Subject: **Response to Portion of NRC Request for Additional Information Letter No. 237 Related to the ESBWR Design Certification – Containment Systems – RAI Number 6.2-180 S01**

**Response to Portion of NRC Request for Additional
Information Letter No. 237
Related to ESBWR Design Certification Application¹**

RAI Number 6.2-180 S01

Figure 6.2-180(1) DW Design Temperature Curve (ENV) vs. TRACG Short-Term Bounding Temperature Curve

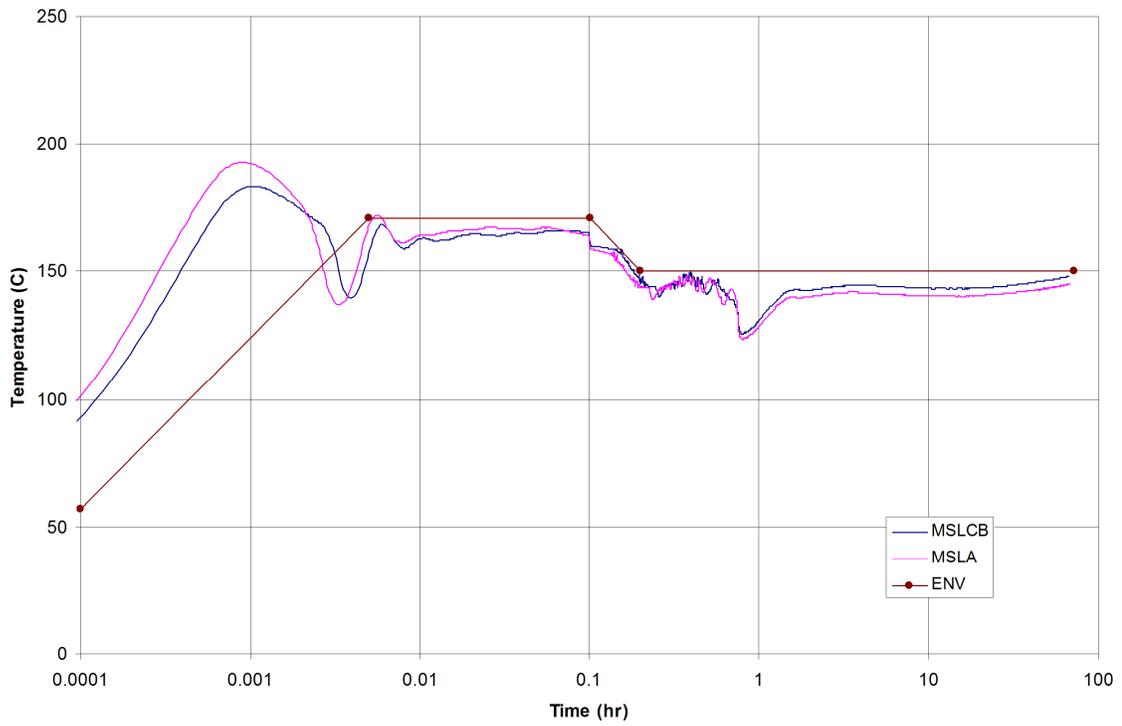
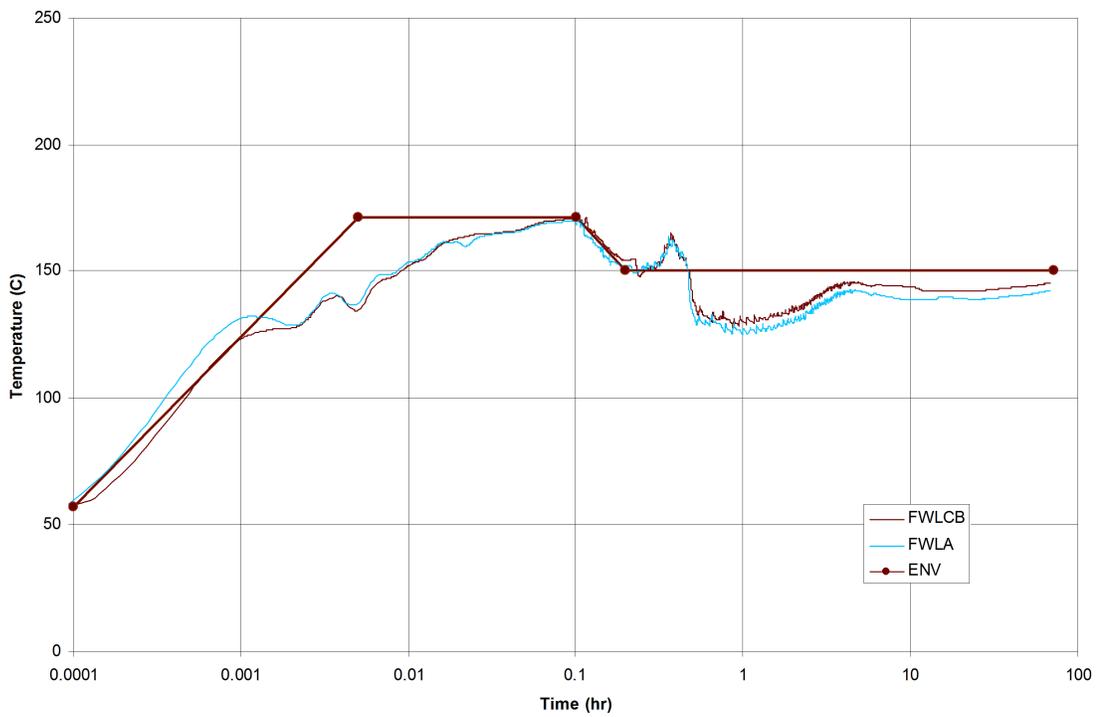
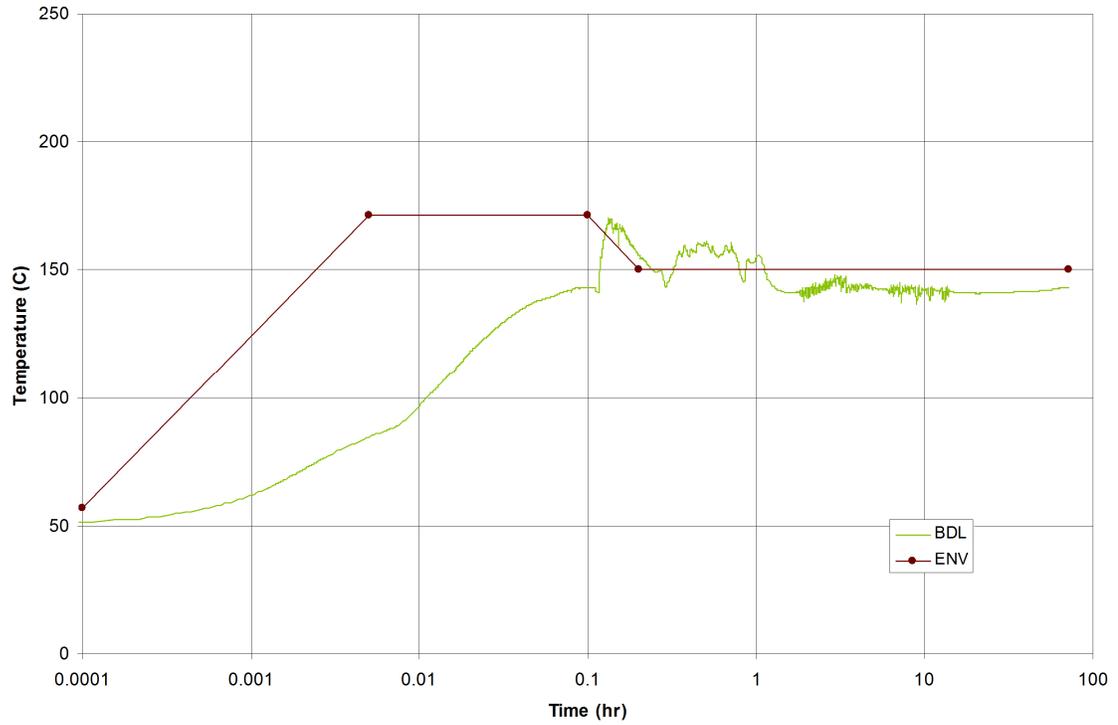
In the response to RAI 6.2-180, GEH stated that for some cases into the transient the drywell bulk temperature is slightly higher than the temperature transient profile considered in the structural analysis. GEH also stated that no impact on structural design is expected, and the effect on structural analysis documented in DCD Tier 2, Appendix 3G, will be taken into account in the detailed design stage. A quantitative evaluation should be performed by GEH as a basis for concluding that the use of a higher thermal transient profile will not impact the structural design. Also, the affected results in DCD Tier 2, Appendix 3G should be annotated to reflect that these results are not based on the latest thermal transient profile identified in the DCD, and that a quantitative evaluation has been performed to conclude that final analysis results will not impact the structural design.

The TRACG temperature curves in the DW are compared with the design temperature curve (labeled ENV) in Figures 6.2-180(1) through 6.2-180(3) for short-term, medium-term and long-term break cases, respectively. It is observed that the MSLA and MSLCB cases result in the highest temperature in the short term ($t < 0.1$ hr); the FWLA and FWLCB cases result in the highest temperature in the medium term ($0.3 < t < 0.5$ hr); and the BDL case results in the highest temperature in the long term ($t > 0.5$ hr). The GDL case is not bounding over any time interval for the DW.

The MSLA case is the most critical because it has the highest temperature at 193°C (379°F) as compared to the 171°C (340°F) peak design temperature. However, this exceedance occurs very early in the transient and is very short in duration. It should be

noted that the TRACG results are bulk fluid temperatures. The actual temperatures in the structures are lower than the fluid temperatures due to heat transfer effects at the surface. The beneficial effects of reduced surface heat transfer are ignored in the structural design analysis in which the design temperature curve was directly applied to the structure assuming an infinite value for the heat transfer coefficient.
